COMMENTS OF CERTAIN CABLE COMPANIES
ON THE NJDEP APRIL 20, 2001 DRAFT SUMMARY
AND RULES REGARDING SUBMERGED CABLES
May 18, 2001

These comments on the above draft (“the Draft”) are submitted on behalf of all of the owners of submarine cables¹ that participated in the Submarine Cable Task Force convened last year (360networks inc., Concert Global Networks USA LLC, Level(3) Communications Inc., Sprint Communications Corp., TyCom, Ltd., and WorldCom, Inc.), plus three other companies (Gemini Submarine Cable System (US) Inc., Southern Cross Cable Network, and its subsidiary Pacific Carriage Ltd.). These companies are collectively referred to here as “the Companies”. We understand that some of the Companies are also submitting their own separate comments.

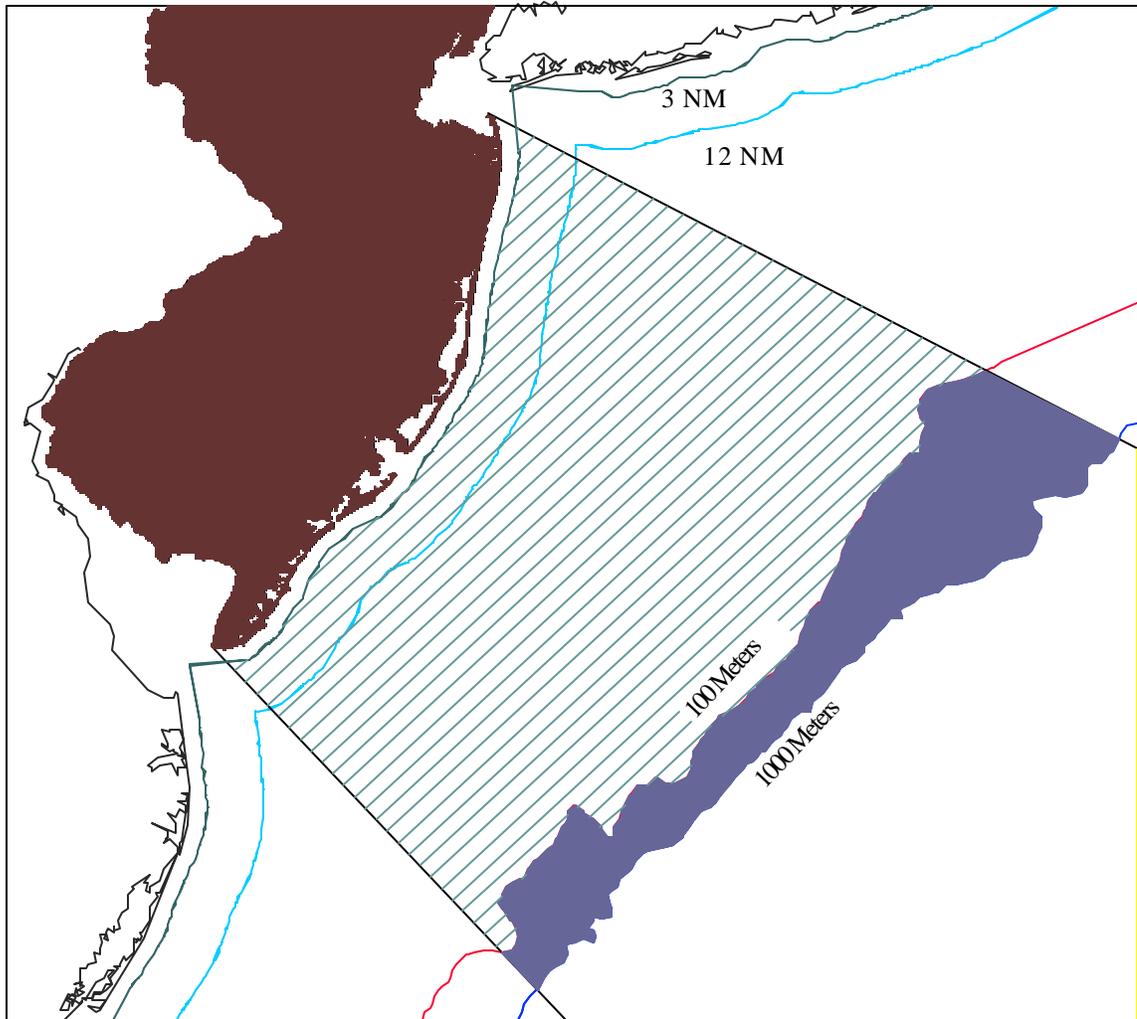
The Draft's requirements generally extend to either 110 meters water depth or to 1000 meters water depth off the coast of New Jersey. These depths are found at distances from shore ranging from about 60 to 80 NM and about 72 to 111 NM, respectively. Therefore most of the requirements of the Draft far exceeds New Jersey's jurisdiction, which ends at three NM. (See the following illustration, provided by TyCom Ltd.)

The Draft therefore should be amended by removing references to 110 meters and 1000 meters. Instead, the Draft and its summary should make clear that the Draft's requirements apply only within the territorial seas of New Jersey.
